Central Planning Authority

Minutes of a meeting of the Central Planning Authority held on **October 12, 2022 at 10:00 a.m. in Conference Room 1038, 1st Floor, Government Administration Building, and Elgin Avenue.**

CPA/24/22

Figure 2: Google imagery showing the application site outlined in red cleared and partially filled.

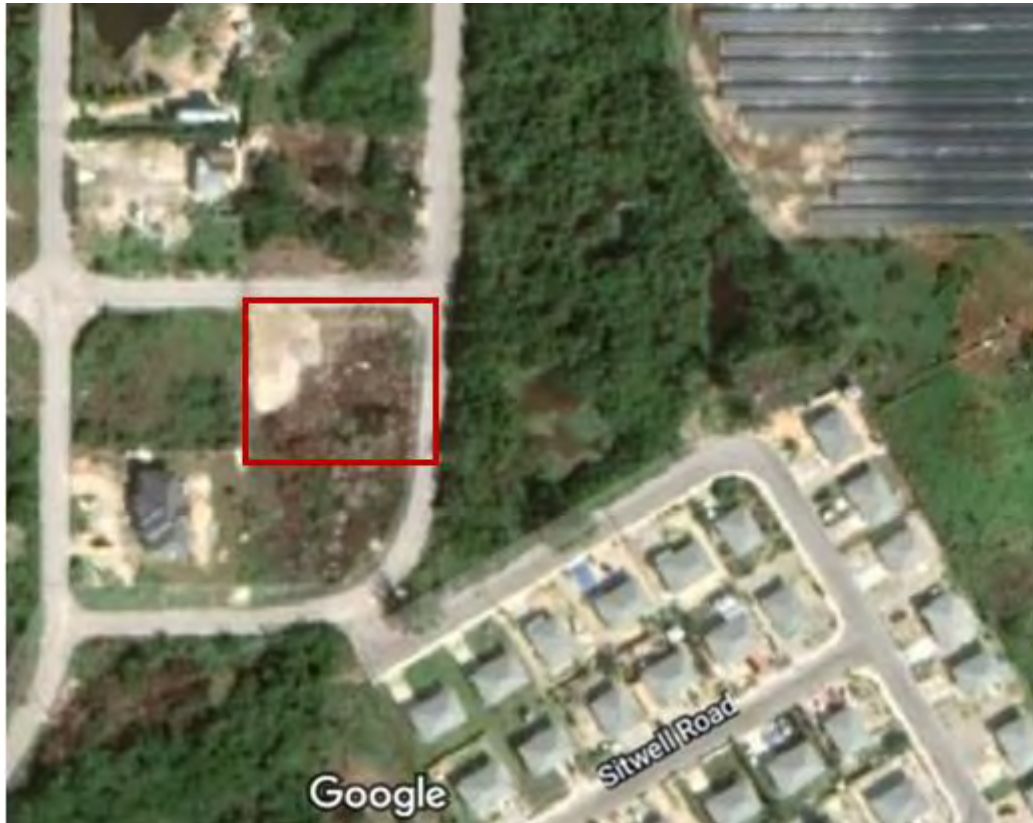
However, Google imagery confirms that the application site has since been cleared and is now man-modified and of limited ecological value (Figure 2).

Given the area is a converted wetland habitat, the parcel and surrounding area are relatively low-lying. It is unfortunate that the wetland vegetation was cleared prior to consultation as the Department would have recommended the retention of the wetland vegetation along the parcel boundaries to act as natural swales and assist with on-site drainage. Nevertheless, we still recommend that stormwater be managed on-site to avoid run-off and prevent the flooding of adjacent properties and the road.

We also recommend that the applicant plants and incorporates native vegetation into the landscaping scheme. Native vegetation is best suited for the habitat conditions of the Cayman Islands, requiring less maintenance and less supplemental irrigation, meaning once it is established, landscaping with native vegetation is a very sustainable and cost-effective choice. Landscaping with native vegetation also has a positive impact on our islands' biodiversity by providing habitat and food for native fauna.

Figure 1: DoE Habitat Map for Block 45A Parcel 80.

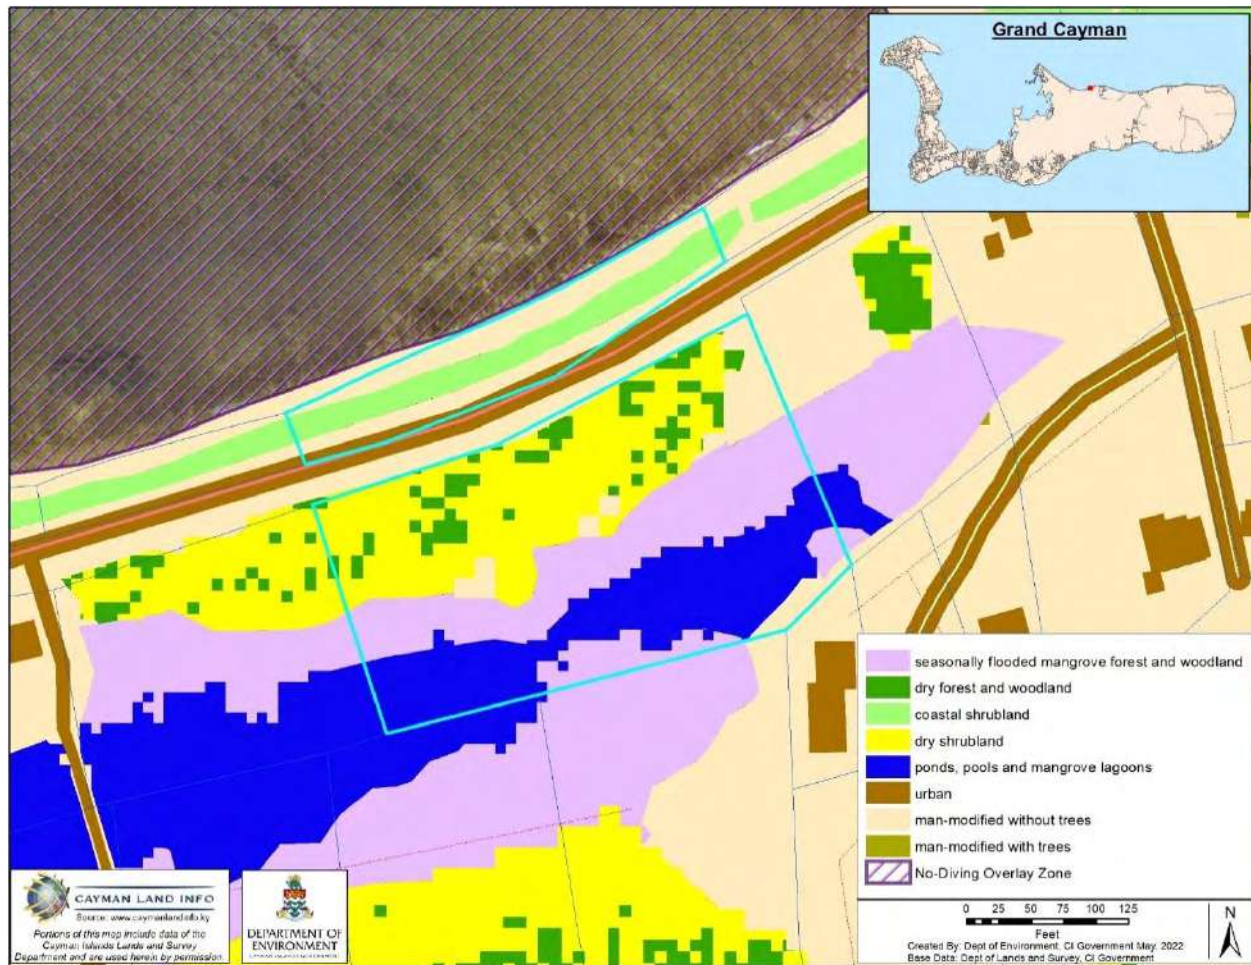
The portion of the application site located north of Rum Point Drive is adjacent to a No Dive Zone which is a Marine Protected Area under the National Conservation Act. The application site consists of a mixture of primary habitat including costal shrubland, dry shrubland and seasonally flooded mangrove habitat as shown in Figure 1.

*We note that the application is for a subdivision, we would **not** support the clearing of this site at this time. Land clearing should be reserved until the development of individual lots is imminent (through the granting of planning permission for development on those particular lots). This allows the opportunity for the individual lot owners to retain as much native vegetation as possible. Clearing the entire site prematurely removes the choice from the individual lot owners and removes the value the habitat could provide in the time between the preparation of a subdivision and the development of an individual lot.*

The DoE also notes that the Applicant confirms in their cover letter that “they intend to leave the pond on the southern portion of the development in its natural state, with no filling”. The DoE supports the retention of the pond and recommends the retention of the pond be included as a condition of the planning permission. In addition, we also recommend that the applicant includes the retention of the pond in covenants for the subdivision.

- 1. The existing pond shall be retained in its natural state and shall not be filled.*
- 2. There shall be no land clearing, excavation, filling or development of the resultant parcels without planning permission for such works being granted.*
- 3. Any future development, clearing, filling or excavation of the resultant parcels shall be the subject of a separate consultation with the Central Planning Authority and National Conservation Council.*

Figure 1: LIS 2018 aerial imagery with the outline of the proposed new buildings from the Applicant's site plan overlaid. Green sea turtle nests are shown in green and Loggerhead turtle nests are shown in orange. The red line delineates the designated critical sea turtle habitat.

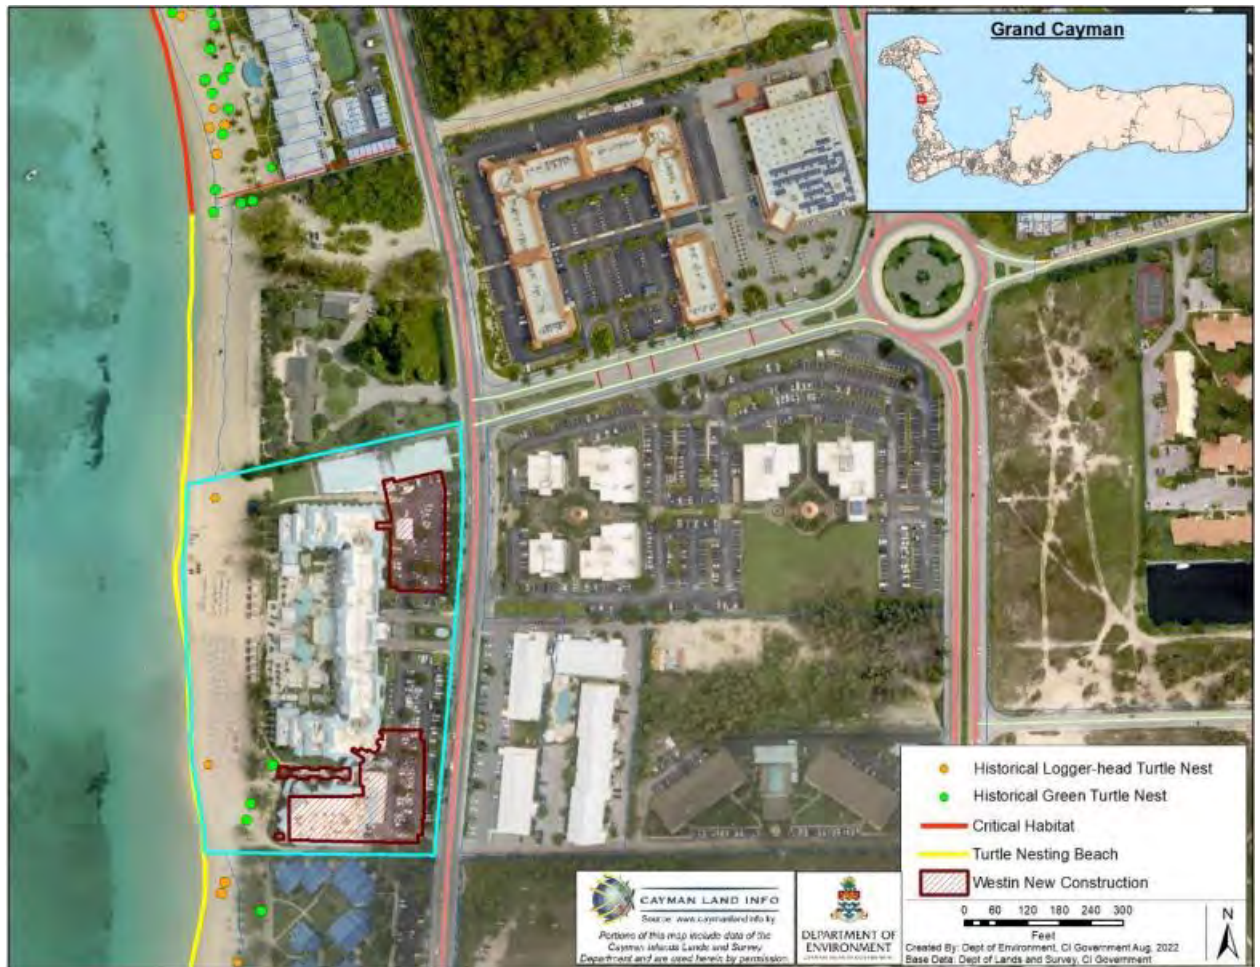
The beach of the subject parcel is a turtle nesting beach. All marine turtle species are listed in Part 1 of Schedule 1 to the NCA, as being 'protected at all times'. There are currently adverse impacts from the existing resort to nesting and hatchling sea turtles from the artificial lighting which directly illuminates the nesting beach. The Applicant has not indicated the use of turtle friendly lighting in the proposed development. Historical nesting on the site has been concentrated to the south (see Figure 1). Currently, a low-level restaurant building occupies the southern section of the resort. With the construction of the proposed 10-storey hotel tower, the impacts of artificial lighting on the historical nesting area of the beach are likely to be amplified due to the cumulative increase in lighting.

The DoE welcomes the removal of the hard structures (including portions of the proposed pool deck, the proposed outdoor seating area, walkways and the proposed fire lane) which were previously included in the 2020 proposal and located within the 130-foot coastal setback and areas which previously experienced turtle nesting.

Figure 14: Digital Terrain Model (DTM) for the application site. The higher areas of the site are indicated in red and orange and show the beach ridge and sand reserves within the site.

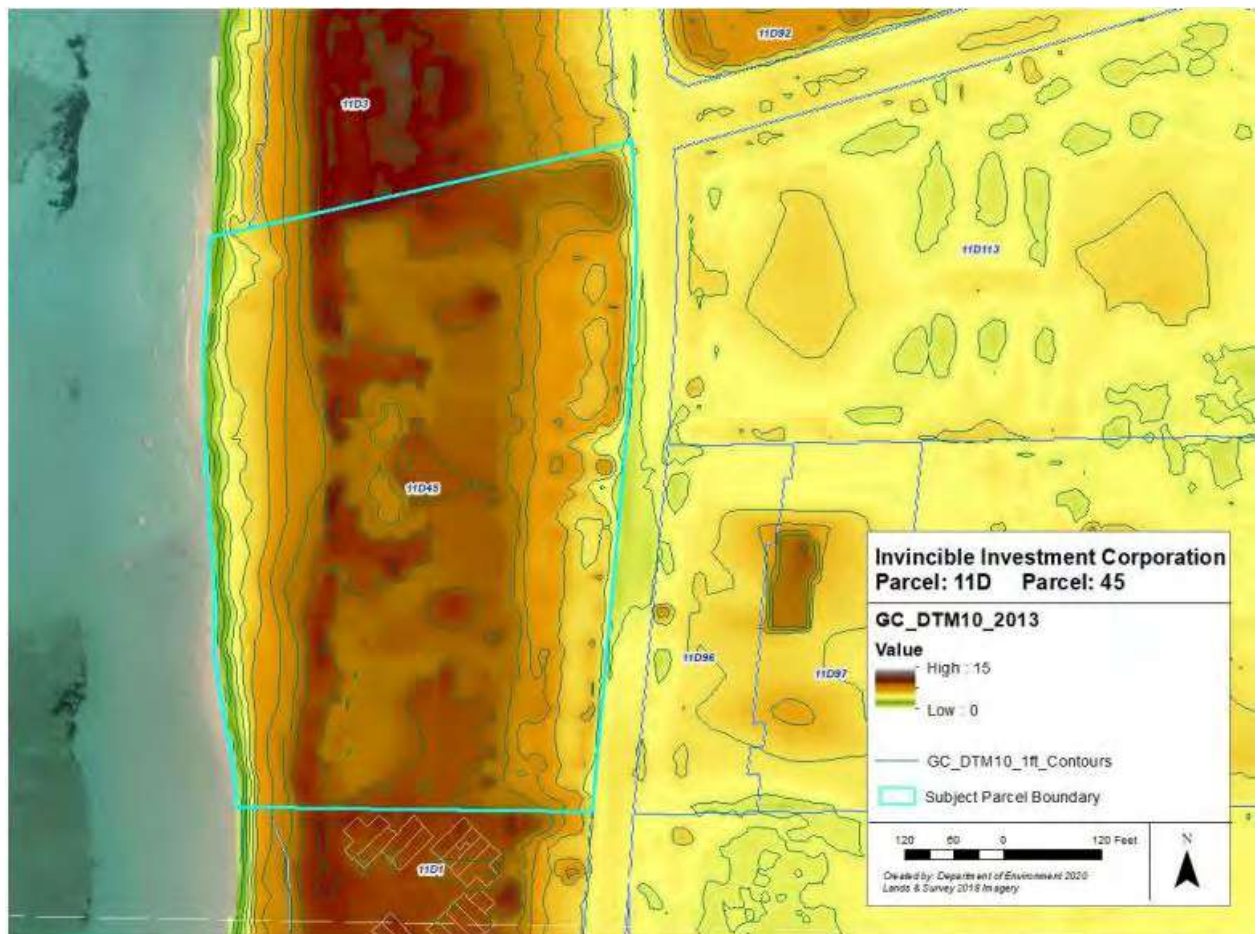
Although the subject parcel is predominantly man-modified, it still consists of massive sand reserves as shown in Figure 14 and the removal of these reserves is a concern. The reserves are important to the resilience of the beach system and are a natural source of sand which replenishes the beach profile after major storms. A significant amount of sand may result from the excavation of the foundations and pool. Once excavated and removed from the beach system, these sand reserves can never be recovered, making the beach system increasingly more vulnerable to erosion, which is exacerbated by the impacts of climate change, especially sea-level rise. We recommend that any excavated sand is kept on-site and placed landward of the High-Water Mark to retain sand reserves and create depth in the beach profile.

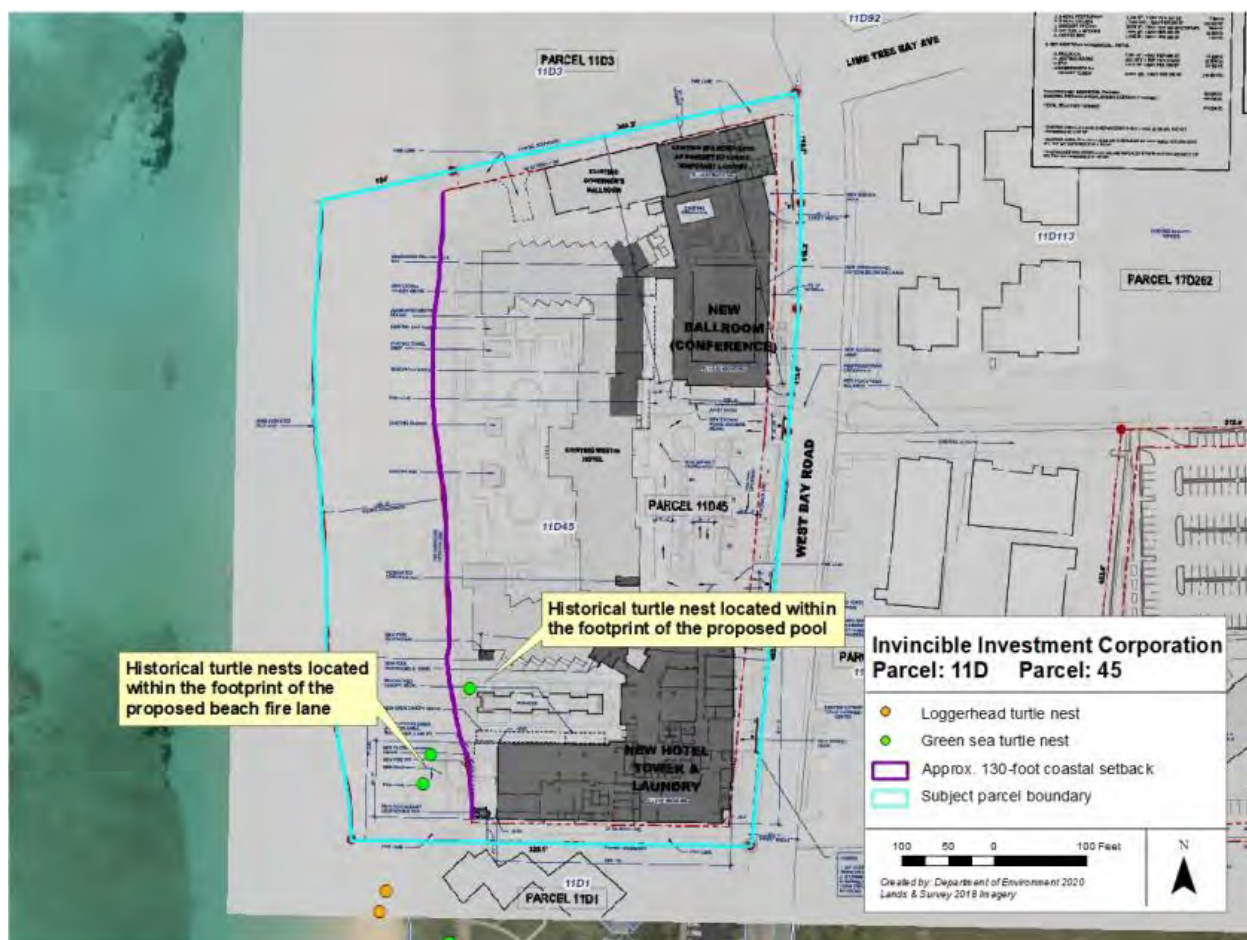
*The site is located on a sea turtle nesting beach, located approximately 253 feet from proposed Critical Habitat under the Draft Conservation Plan for Sea Turtles (2019), see Figure 1. Based on the DoE's 20 years of monitoring sea turtle populations, the site has experienced nesting from green (*Chelonia mydas*) sea turtles in the past however there is still the potential for loggerhead (*Caretta caretta*) sea turtles to also nest on the beach. There are currently adverse impacts to nesting and hatchling sea turtles from the artificial lighting which directly illuminates the nesting beach from the existing resort. The Applicant has not indicated the use of turtle friendly lighting in the proposed development. Historical nesting on the site has been concentrated to the south (see Figure 2). Currently, a low-level restaurant building occupies the southern section of the resort. With the construction of the proposed 10-storey hotel tower, the impacts of artificial lighting on the historical nesting area of the beach is likely to be amplified due to the cumulative increase in lighting.*

The Applicant has not requested any variances to the Development and Planning Regulations coastal setbacks, however, as shown in Figure 2, portions of the proposed pool deck, the proposed outdoor seating area and the proposed fire lane are all located within the 130-foot setback from the Mean High Water Mark. These areas of the proposed development also have historical turtle nests located within their footprints. Hard structures located within the 130-foot setback e.g. the fire lane on the beach, decrease the size of the potential turtle nesting habitat.

Figure 1: LIS 2018 aerial imagery showing the application site outlined in red.

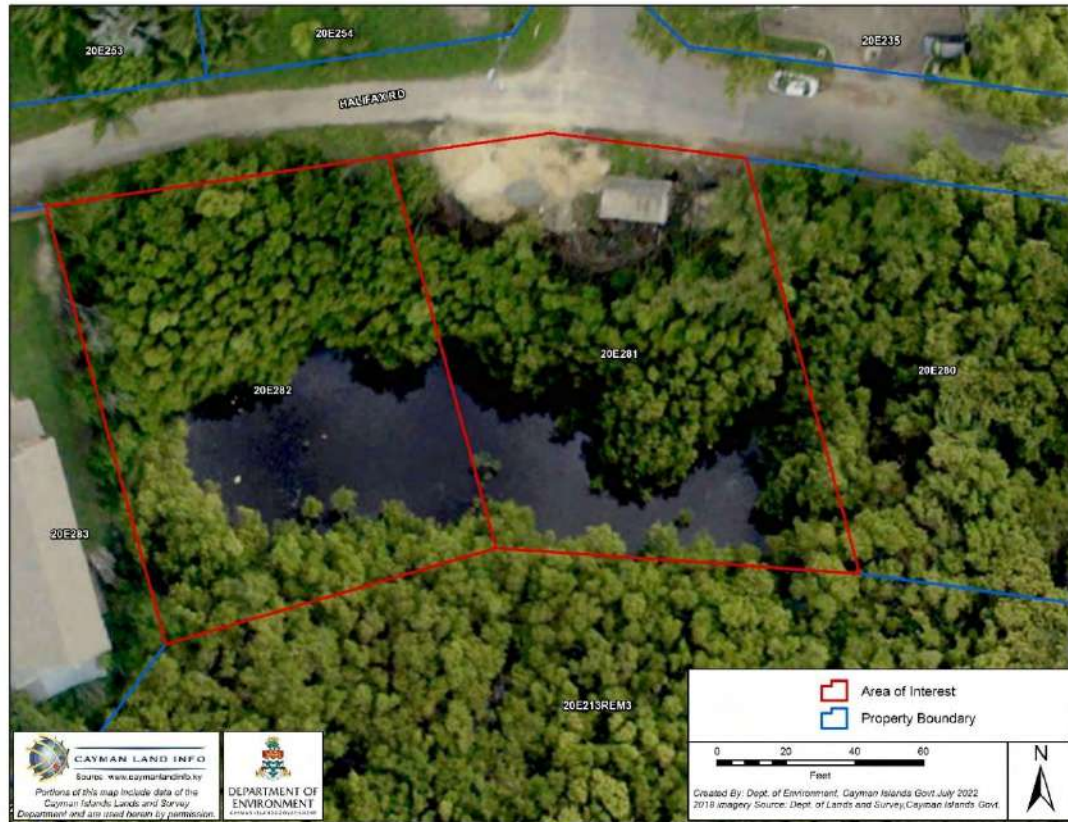
The application site was previously man-modified and consists of secondary wetland habitat as shown in Figure 1. The site is located in the South Sound drainage basin and is connected to a wider area of wetland to the south (see Figure 2). The site is considered to be "wet" and low-lying. We recommend that a storm water management plan is developed for the site, as the proposed development would reducing the drainage capacity of the remaining surrounding wetland. Reducing the drainage capacity of the wetlands increases the likelihood and severity of flooding in the surrounding area. The stormwater management plan should be designed in a way to allow for site derived runoff to be handled on site without impacting the surrounding area.

The applicant should be encouraged to clear and fill only the development footprint to allow for the remaining existing vegetation and the remainder of the site to be landscaped with vegetation that can tolerate wet conditions, to assist with site drainage. The stormwater management for the site should include measures such as keeping the areas within the side and rear setbacks unfilled and the retention of wetland vegetation within these areas to act as natural swales and assist with on-site drainage.
